# METROPOLITAN GOVERNMENT OF NASHVILLE AND DAVIDSON COUNTY

## STAFF RECOMMENDATION 1906 Holly Street August 21, 2013

**Application:** New construction-addition  
**District:** Lockeland Springs-East End Neighborhood Conservation Zoning Overlay  
**Council District:** 06  
**Map and Parcel Number:** 08314007900  
**Applicant:** Ronee Swafford and Daniel Long  
**Project Lead:** Melissa Baldock, melissa.baldock@nashville.gov

<p><b>Description of Project:</b> The applicant is proposing to construct a one-story addition to a one-story house.</p> <p><b>Recommendation Summary:</b> Staff recommends approval of the project with the following conditions:</p> <ol style="list-style-type: none"><li>1. The addition be inset a minimum of one foot (1') from each of the side walls of the house.</li><li>2. Staff review and approve the window and door specifications and the asphalt shingle color, and the concrete block be split faced.</li><li>3. The major measurements, including eave height, ridge height, width, depth, etc., be marked on all drawings prior to issuing the permit.</li></ol>	<p><b>Attachments</b> <b>A:</b> Photographs <b>B:</b> Site Plan <b>C:</b> Elevations</p>
--	--

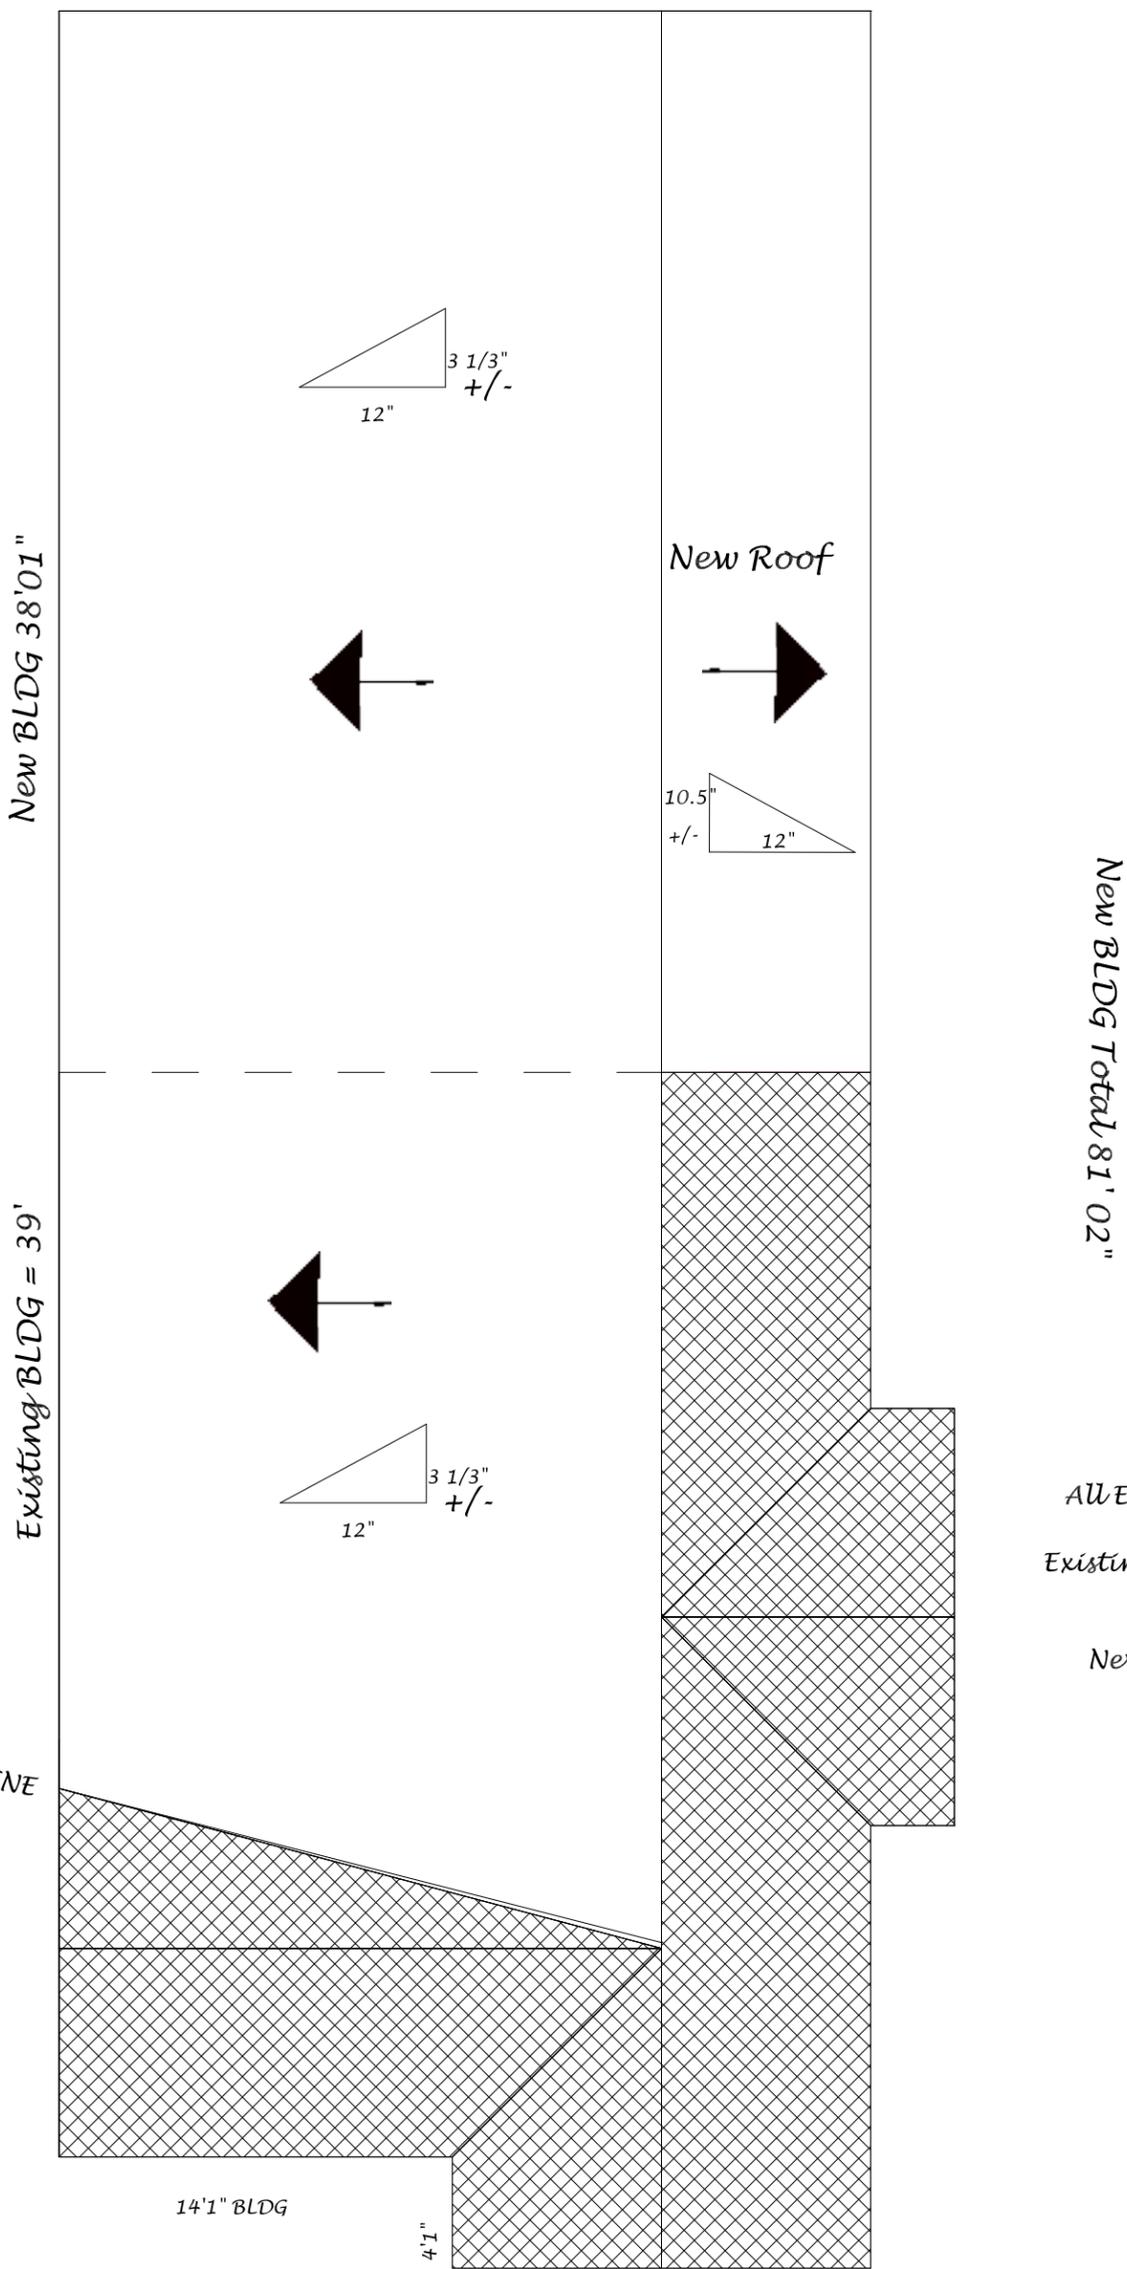
Location and Setback: The proposed addition meets all base zoning requirements for setbacks, and it is located at the rear of the building. Staff therefore finds that proposed addition meets Sections II.B.3 and II.B.10 of the *Lockeland Springs-East End Neighborhood Conservation Zoning Overlay: Handbook and Design Guidelines*.

The addition does not step in from the back side walls of the house but continues the line of the existing house on both sides. The design guidelines states, “*Generally rear additions should inset one foot, for each story, from the side wall.*” When the Commission and staff have approved insets of less than one foot (1') in the past, it has generally been because there is a change in materials or other specific features of the addition that differentiate it from the historic structure. In addition, the additions with minimal insets have been more modest in scale than the one proposed. Because the proposed addition does not involve a change in material or other feature to differentiate it from the existing house, and because the addition nearly doubles the footprint of the house, staff finds it is critical that the addition step in at least one foot (1') from the side

walls of the house. After an initial inset, the addition can step back out to match the line of the house.

1. The addition be inset a minimum of one foot (1') from each of the side walls of the house.
2. Staff review and approve the window and door specifications and the asphalt shingle color, and the concrete block be split faced.
3. The major measurements, including eave height, ridge height, width, depth, etc., be included on all drawings, prior to issuing the permit.

# ROOF PLAN

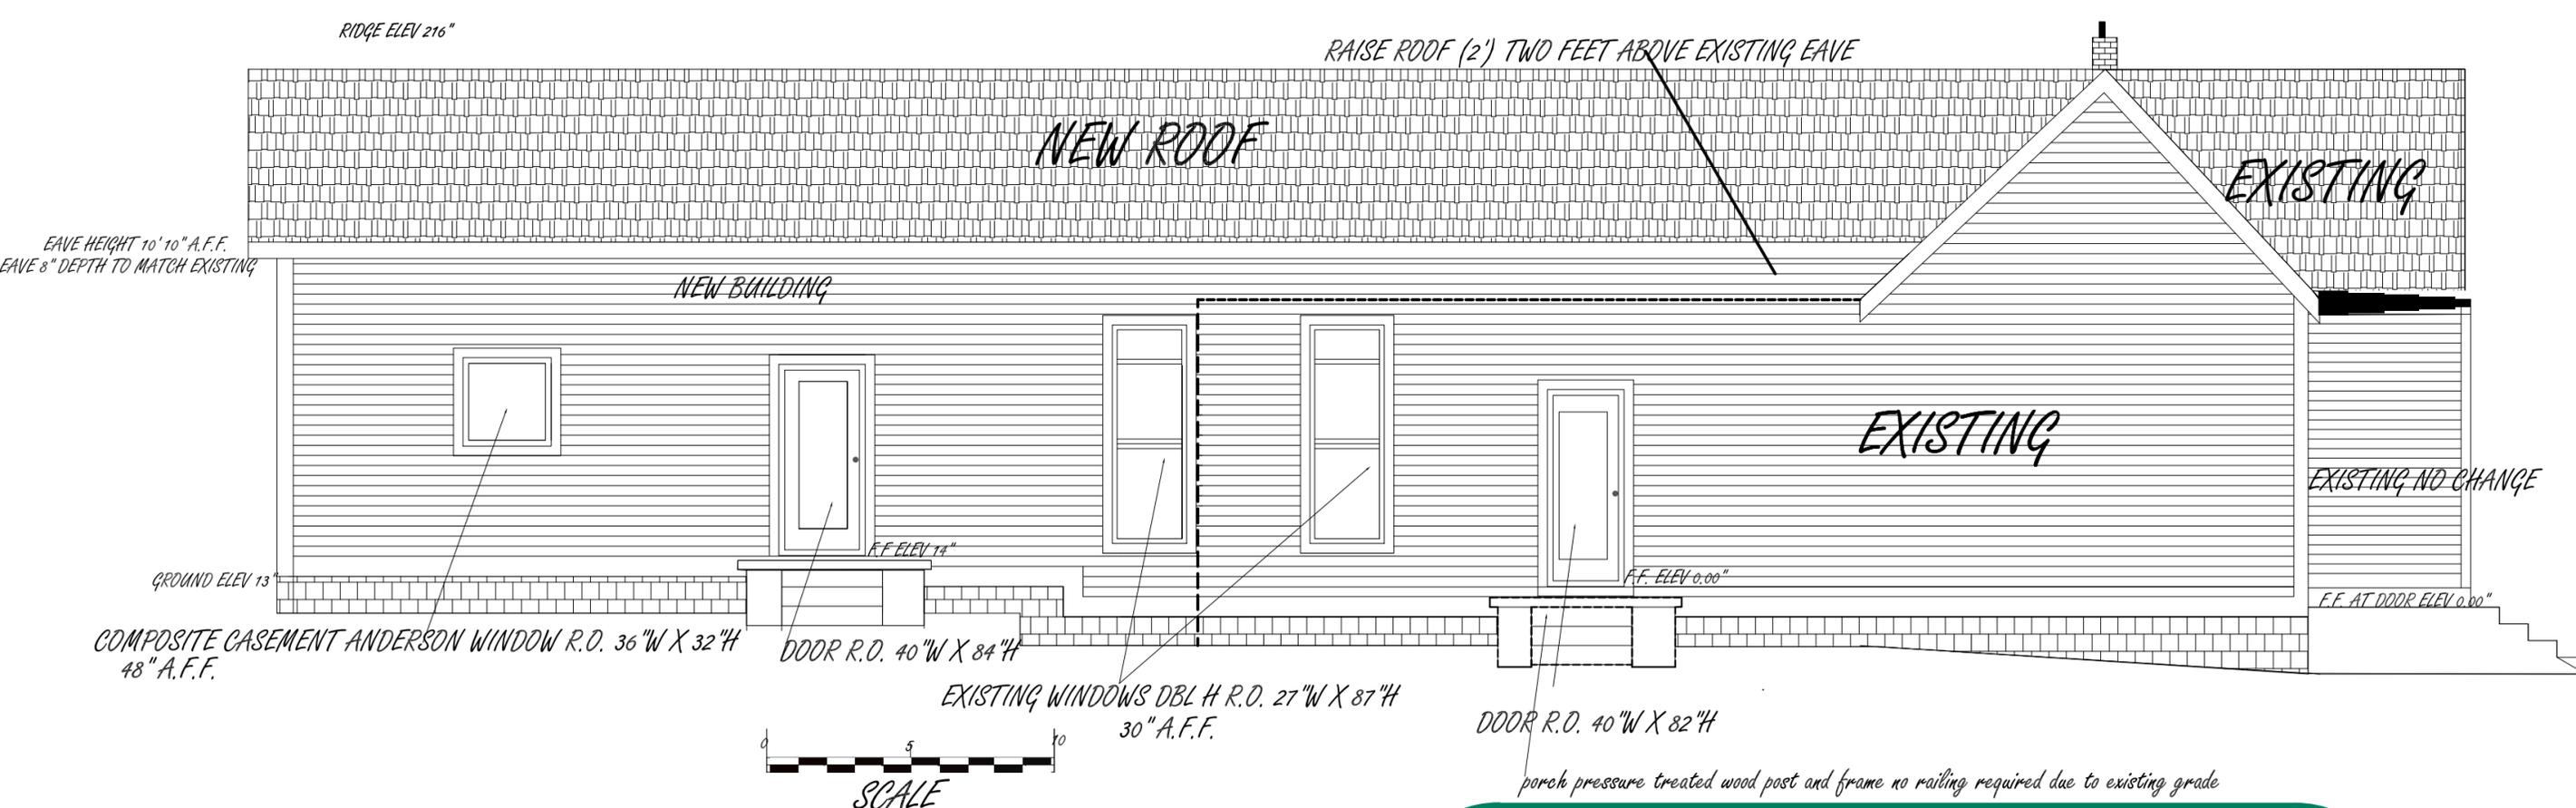
Roof: This historic house has a gabled ell form with an approximate 10.5/12 slope. On the west elevation, the addition will continue the roof form of the house and will match the existing slope. On the east side, a shed roof with a slope of approximately 3.5/12 will be added. Although the design guidelines typically like to see a slope of at least 6/12, staff finds the 3.5/12 slope to be appropriate because the existing addition also has a shed roof with a low slope, and the lower slope will help differentiate the addition from the historic house.

The shed will tie into the point of the cross gable. The new shed roof will require the removal of some of the original roof form. A portion of the back slope of the east side gable will be removed, and the eastern slope of the back gable will be removed entirely. Staff finds that if the addition steps in one foot (1') from each of the house's sidewalls, thereby differentiating the existing house from the addition, the alteration to the house's historic roof form is acceptable. The front portion of the roof will remain largely unaltered, and enough of the roof will remain for the original roof form to be discernible.

With the condition that the addition step in a minimum of one foot (1') from each of the house's side walls, staff finds that the roof form meets Sections II.B.5. and II.B.10. of the *Lockeland Springs-East End Neighborhood Conservation Zoning Overlay: Handbook and Design Guidelines*.

## EASTSIDE ELEVATION

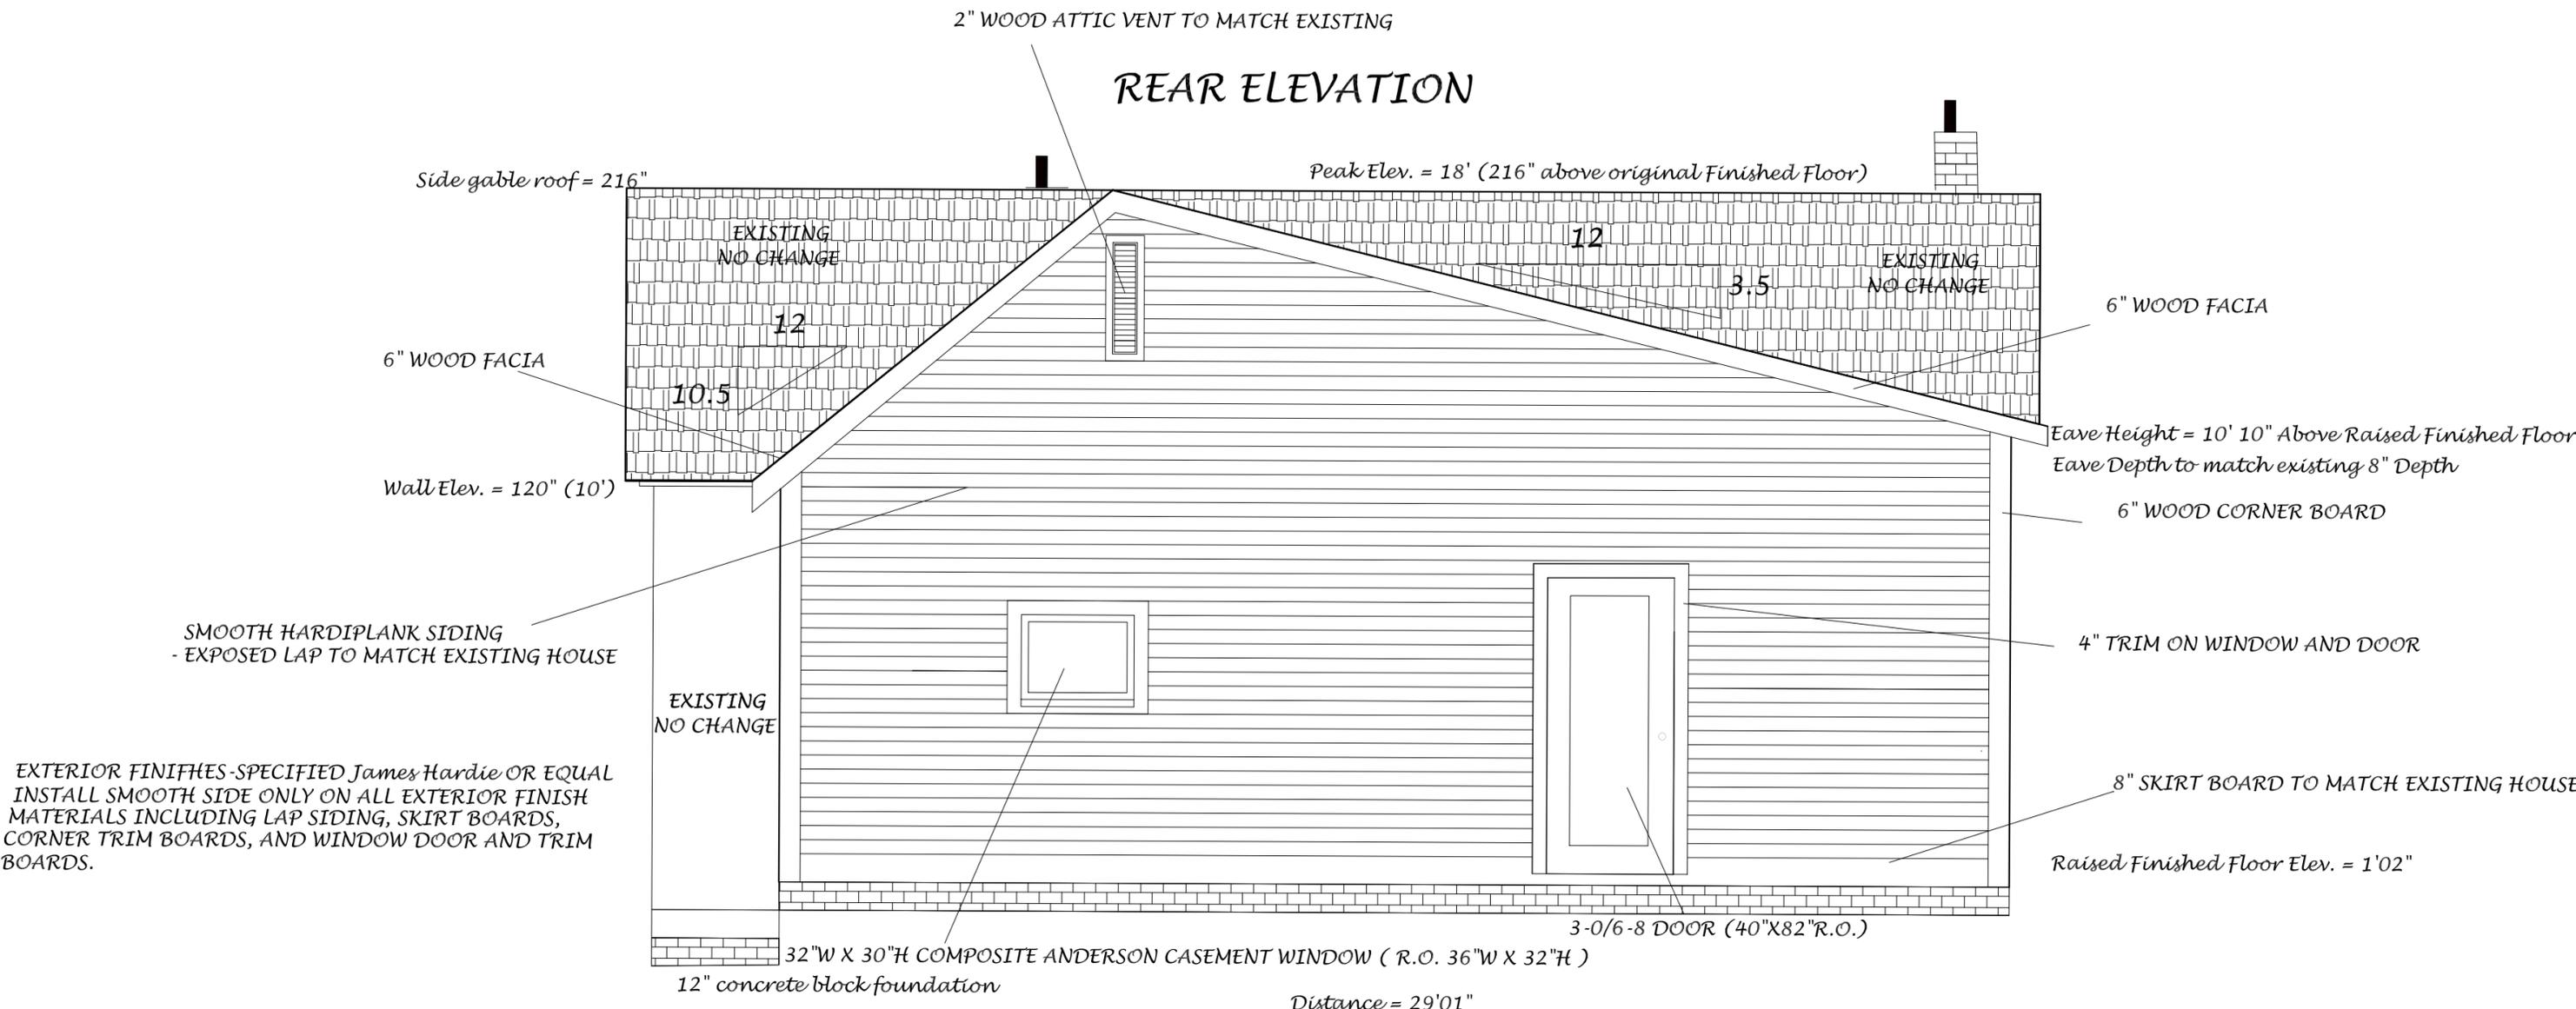
Height & Scale: The proposed addition is no taller and no wider than the existing house. The historic house is approximately twenty-one feet (21') tall, thirty-three feet (33') wide, and forty-three feet (43') deep. The addition will add approximately thirty-eight feet (38') to the back of the house. On the east elevation, the applicant is proposing to raise the height of the existing addition by two feet (2'), and the new addition will continue back from that point. On the west elevation, the addition will extend from the existing back gable.

On the west elevation the addition's eave height and ridge height will match that of the historic structure. On the east elevation, the eave height will be two feet (2') taller than the existing eave height, but the ridge height will match that of the historic house. The foundation height of the addition will step up approximately one foot (1') on both sides of the addition in order to accommodate the site's slope and to reflect an interior step. Although staff typically asks that the foundation of an addition match the height of the historic house's foundation line, the site of the slope makes the increase in foundation height necessary.

Proportion and Rhythm of Openings: The drawings indicate a few changes to the door and window pattern of the existing house. On the east elevation, the applicant is proposing to remove two window opening and install a new doorway and a new window opening. Staff finds these changes to the openings appropriate because they are located on the portion of the existing house which was built after 1986. On the west elevation, the applicant is proposing to remove an existing tall and narrow window opening and replace it with an opening that is two feet, six inches by four feet, four inches (2'6" X 4'4"). Staff finds the alteration of this window opening to be appropriate because the
